Addendum 2  
April 2006

API RECOMMENDED PRACTICE 7L  
FIRST EDITION, DECEMBER 1995

Replace Appendix A with the following:

## **APPENDIX A—RECOMMENDED PRACTICE FOR OPERATING LIMITS, INSPECTION, CARE, AND USE OF CEMENT HOSE, DRILLING MUD VIBRATOR AND JUMPER HOSE, AND ROTARY HOSE**

Figure A.1—Layout for Rotary Hose

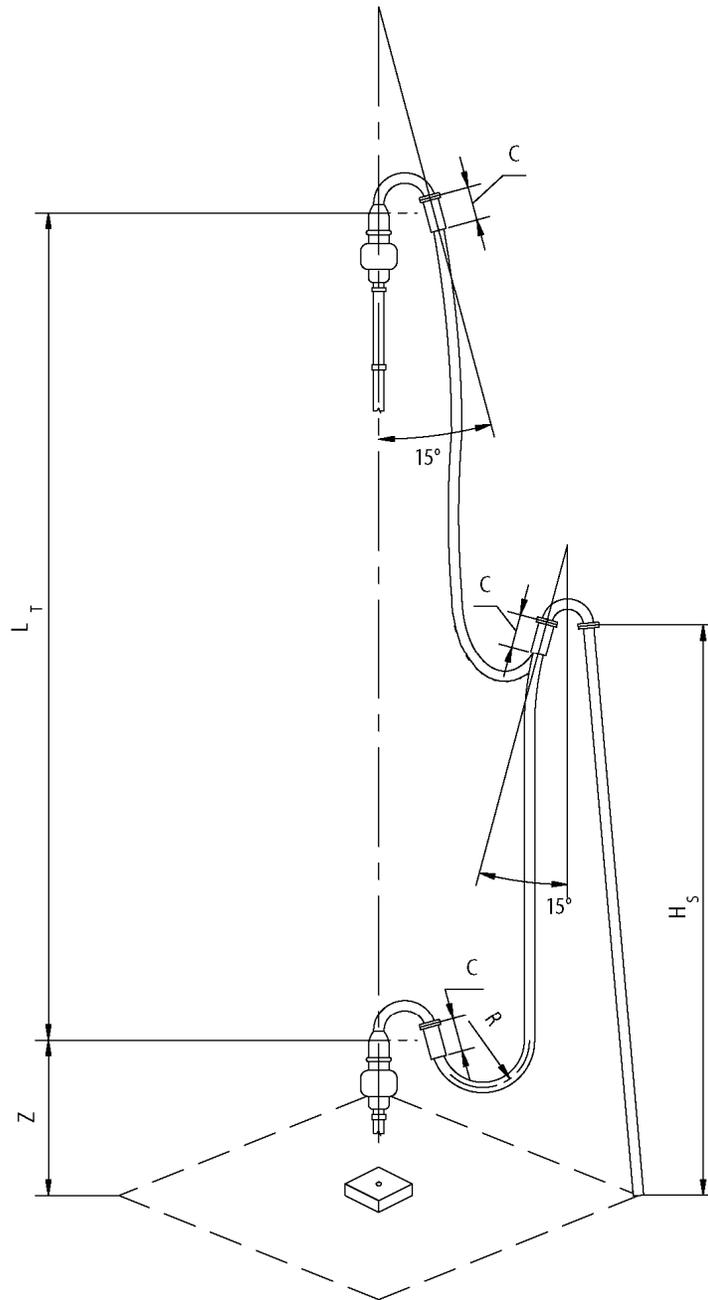
In order to avoid kinking rotary hose, the length of hose and height of standpipe should be such that while raising or lowering the traveling equipment, the bending radius of the hose will not be less than the value of the Minimum Bending Radius (MBR) provided in Table 7 and C.1 of API Spec 7K at the swivel when the traveling equipment is in its lowest drilling position and at the standpipe when the traveling equipment is in its highest drilling position. The recommended length of rotary hose is derived by the following equation (see Figure A.1).

$$L_H = L_T/2 + \pi R + 2C + S \quad (\text{A.1})$$

The recommended standpipe height is derived by calculation using the following equation (see Figure A.1).

$$H_s = L_T/2 + Z \quad (\text{A-2})$$

Note: When the actual length of hose is greater than the length calculated in A.2, the standpipe height should be increased by one-half the difference between the actual length and the calculated length.
